GPIO Issue review

Model Name: BFX-UA300

Document Version: ALT_STB_MP_CSMTINS_001

Issued Date: 2022.04.28

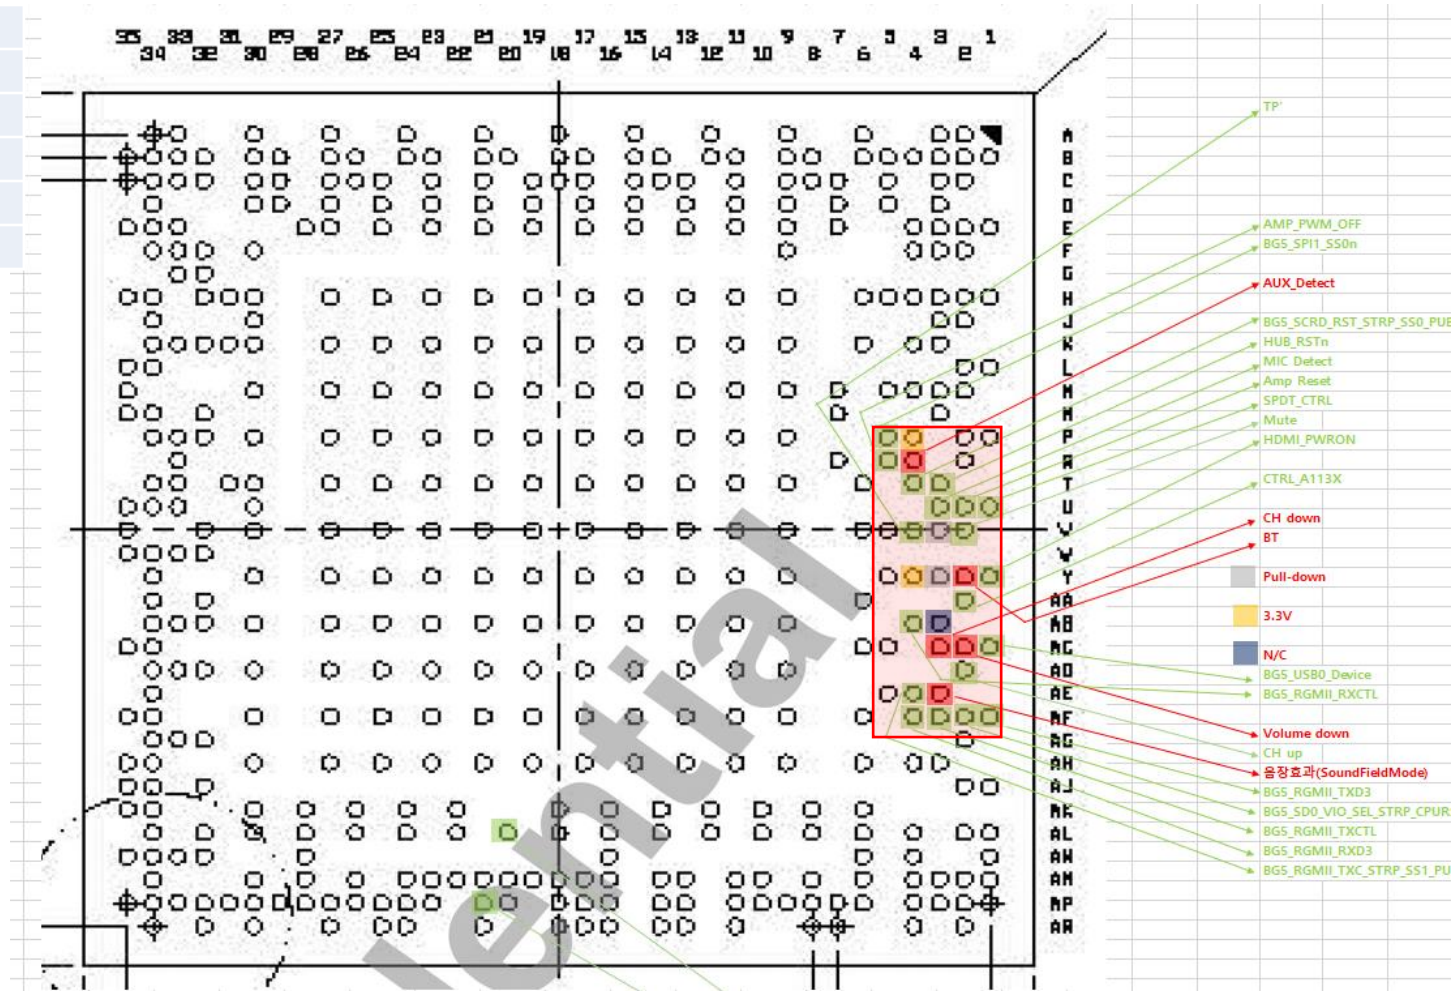
a. button being pressed repeatedly.

- "CH-" 2pcs,
 - 2149695001202109001335 A8934AFE8191
 - 2149695001202109001199 A8934AFE8209
- "Vol-" 1pcs,
 - PCBA S/N : YW61SVG
- "BT paring" 1pcs,
 - 2149695001202109001011 A8934AFE8265
- "Soundeffect" 1pcs
 - 2149695001202109001817 A8934AFE7EE0

b. AUX not working : 2pcs

- 2149695001202109002264 A8934AFE7F26
- 2149695001202109001321 A8934AFE8105

X-ray inspection

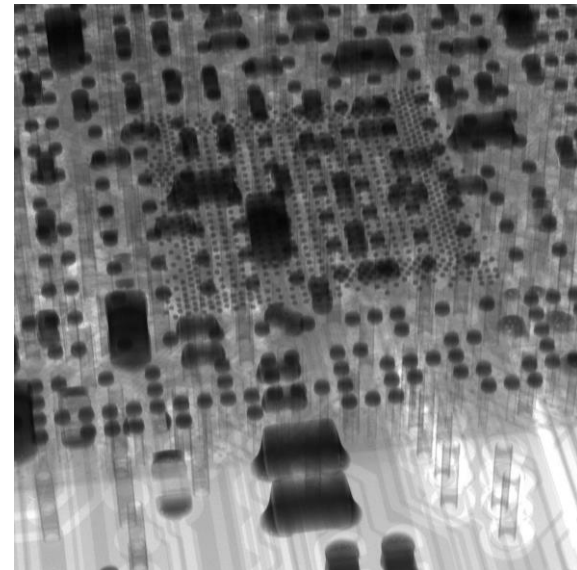
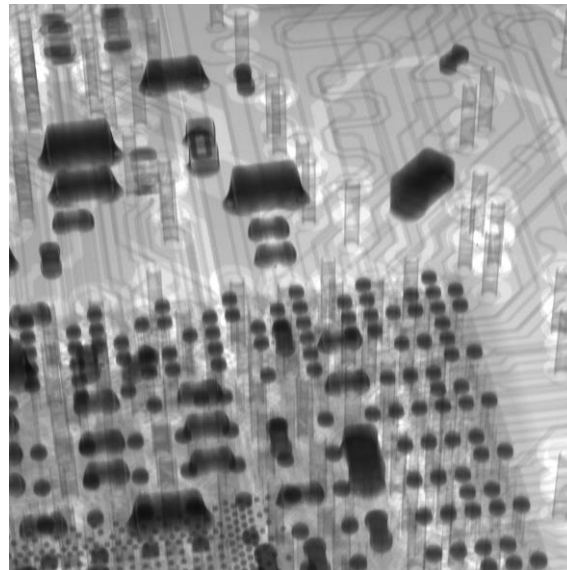
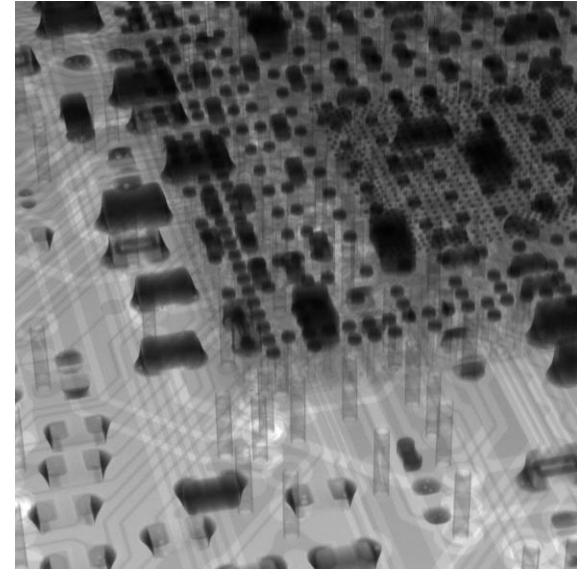
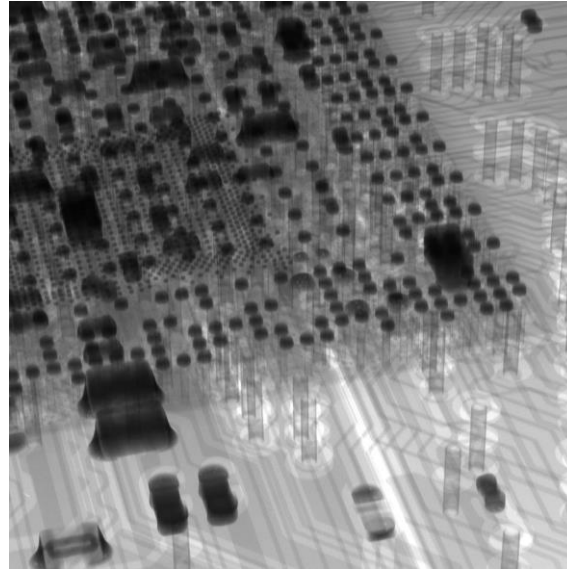
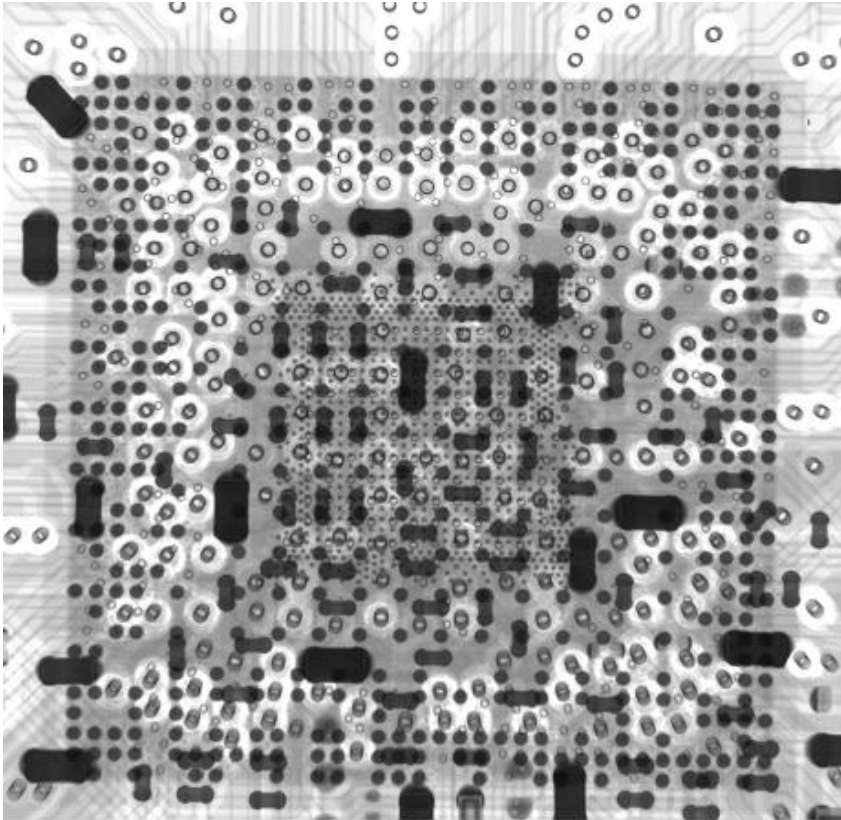
- No Found abnormal : VS-550

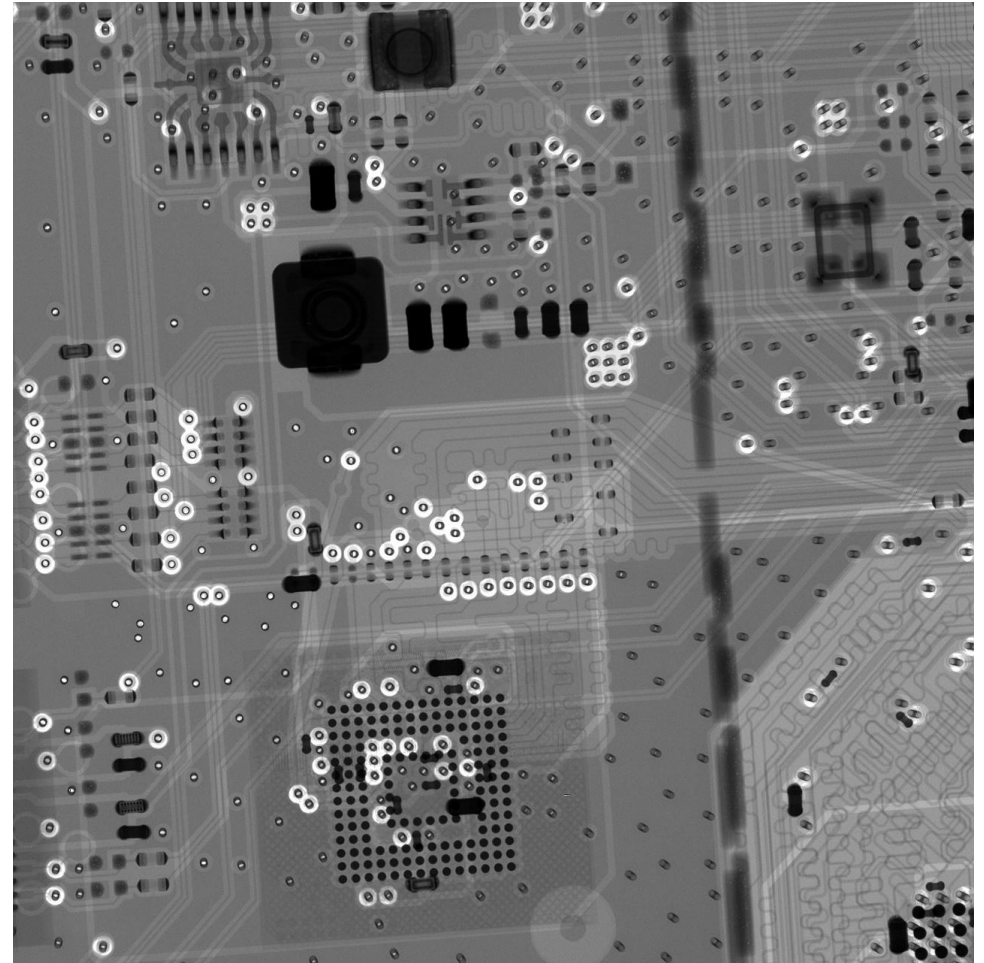
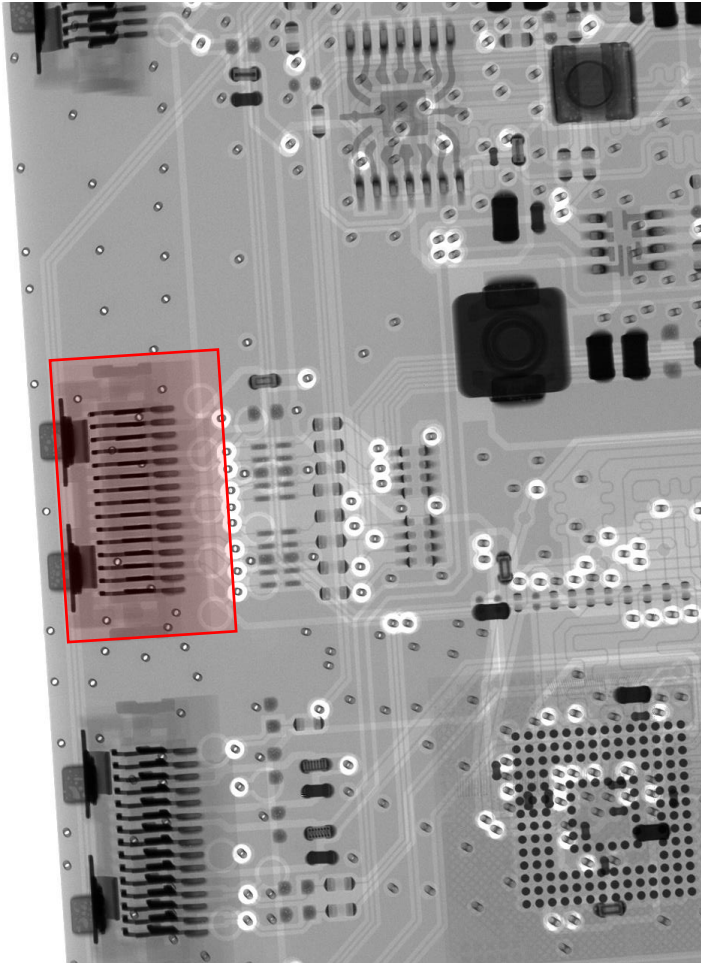
- Button PCB pattern : No Found abnormal

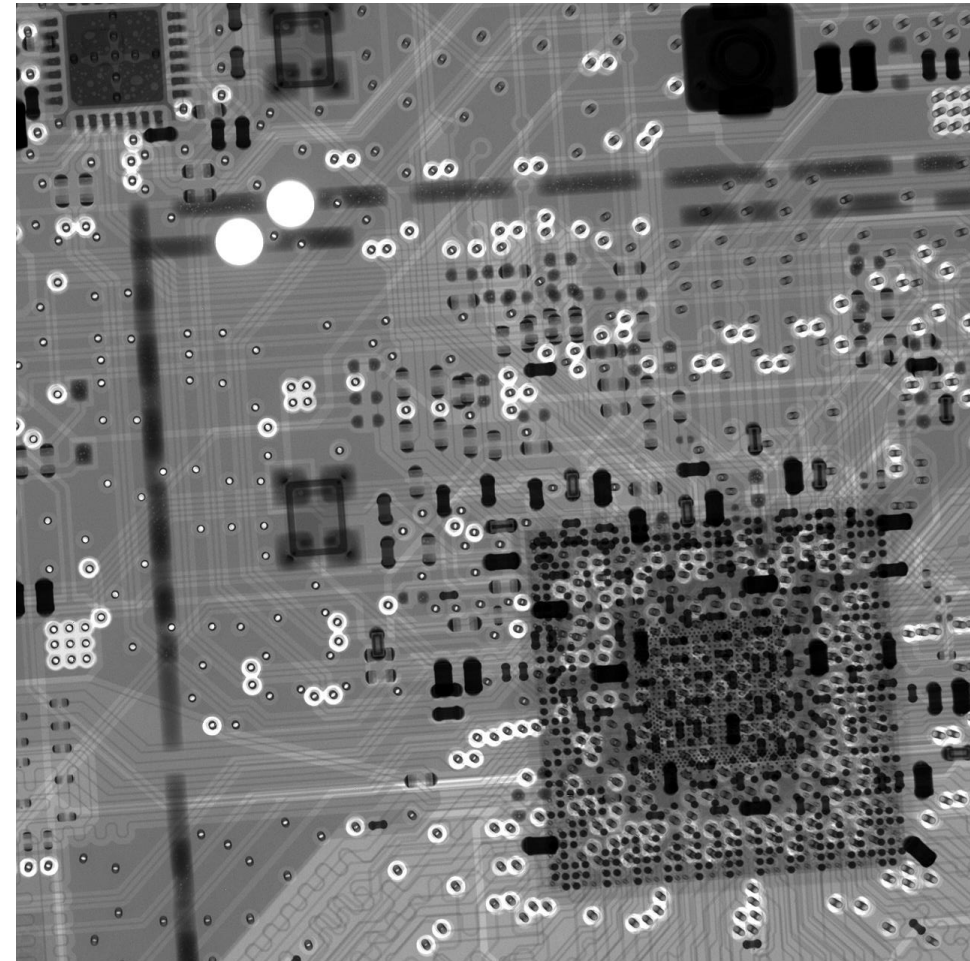
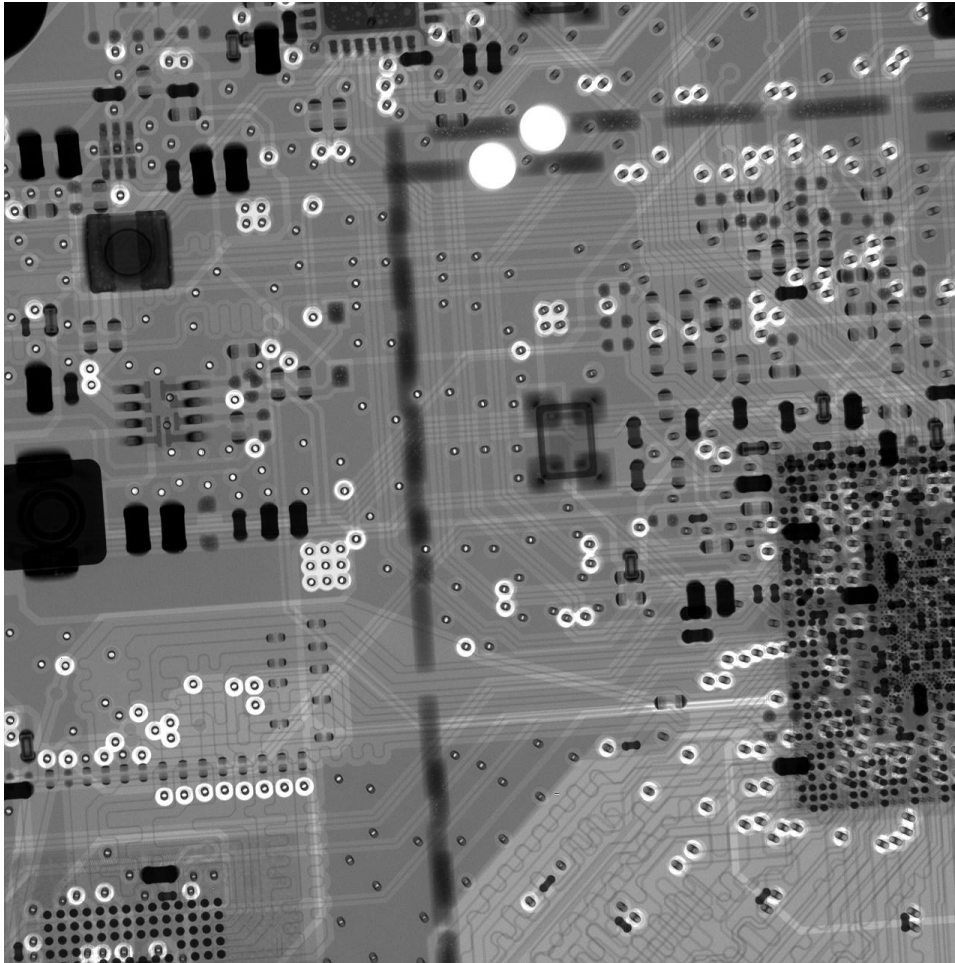
- Button PCB pattern : No Found abnormal

Signal check

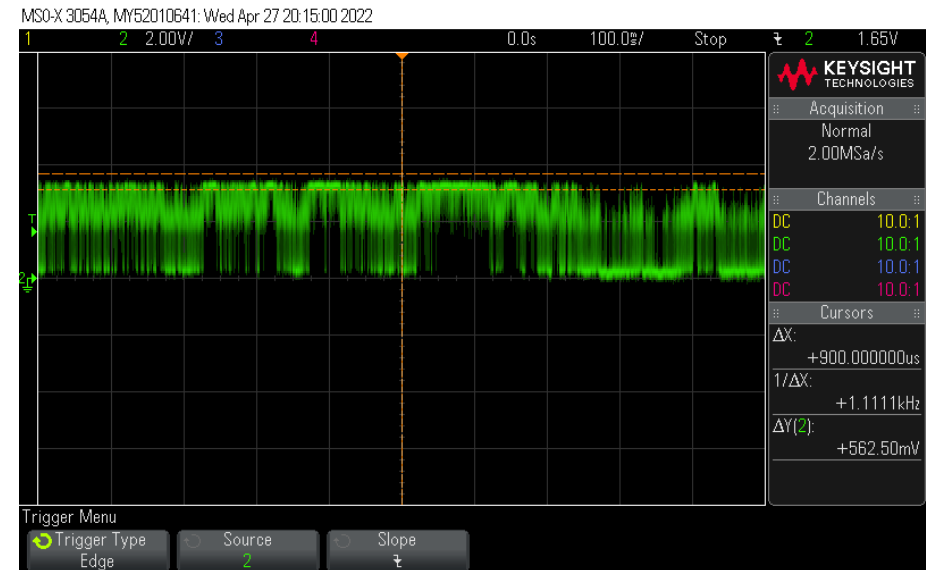
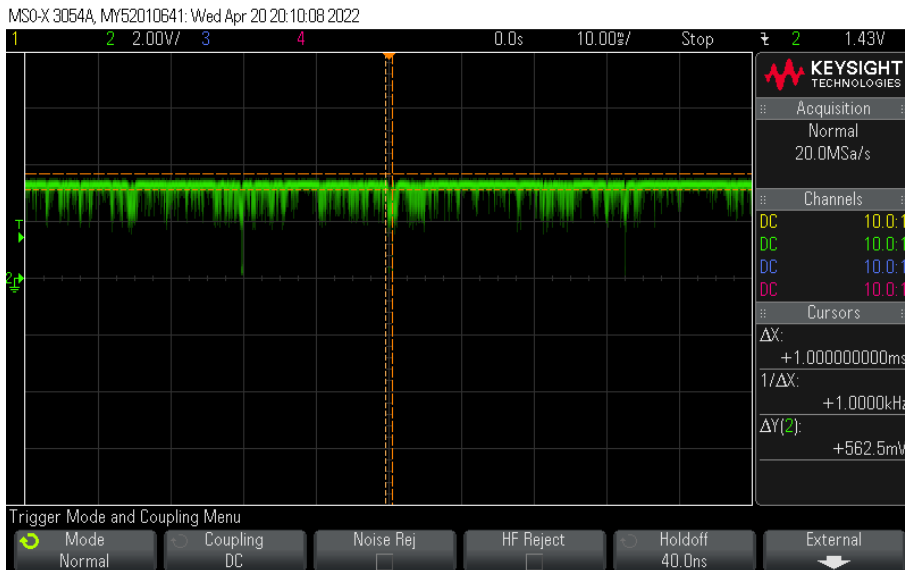
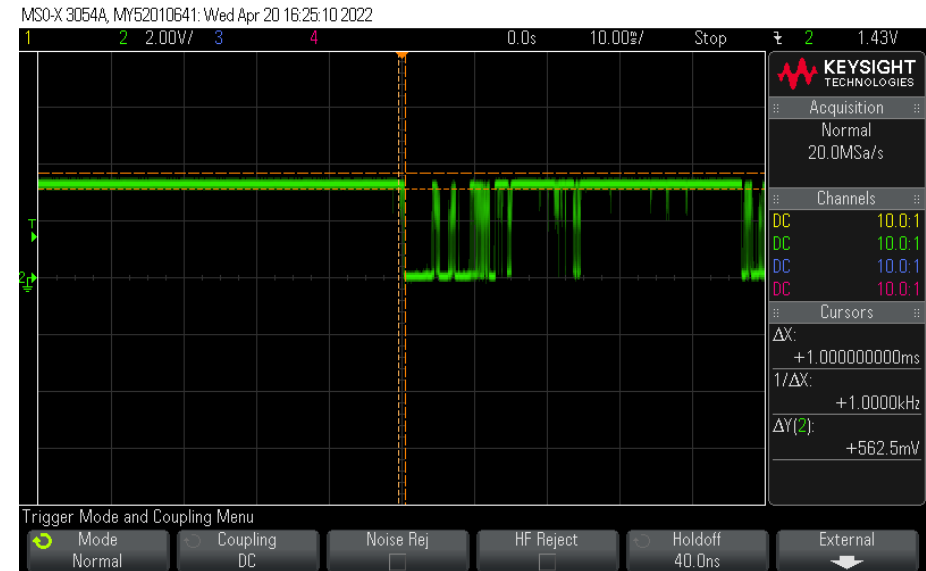
- Measure the “Vol-”, AC2 pin the signal when defects appear is abnormal

- These GPIO pins of VS-550 are located in the same area.
- ALT will analyze the following causes
 - a. PCB defect.
 - b. Soldering defect
 - c. Chip(VS-550) defect

- NEED TO ANALYZE AND FIND THE ROOT CAUSES
- Foxconn have to analyze the following causes
 - a. PCB defect.
 - b. Soldering defect
 - Factory should check the SMT log to review if there is an abnormal.
 - So far, the defects have been concentrated on the initial production.
 - S/N range : 2149695001202109001011 ~ 2149695001202109002264
 - c. Chip(VS-550) defect
